IN THE UNITED STATES PATENT AND TRADEMARK OFFICE

Applicants : Koellner et al.
Serial No. : 10/562,172
Filed : December 21, 2005
For : Door Module
Group Art Unit : 3634
Confirmation No. : 1304
Examiner : Gregory J. Strimbu

AMENDMENT UNDER C.F.R. § 1.116

Fig. 2a

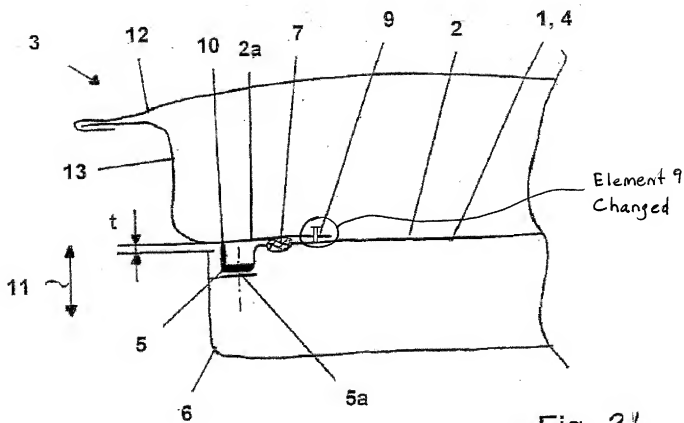
The attached sheet of drawings contains changes to Figure 2b. This figure, which contains Figures 2a and 2b, replaces the original sheet containing these drawings. In Figure 2b, element 9 has been changed for the purpose of clarity.

The drawings stand objected to because it is unclear how, in Figure 2b, element 9 represents a locking lug 9. In view of the amendment to the drawings, Applicants respectfully request the withdrawal of this objection.
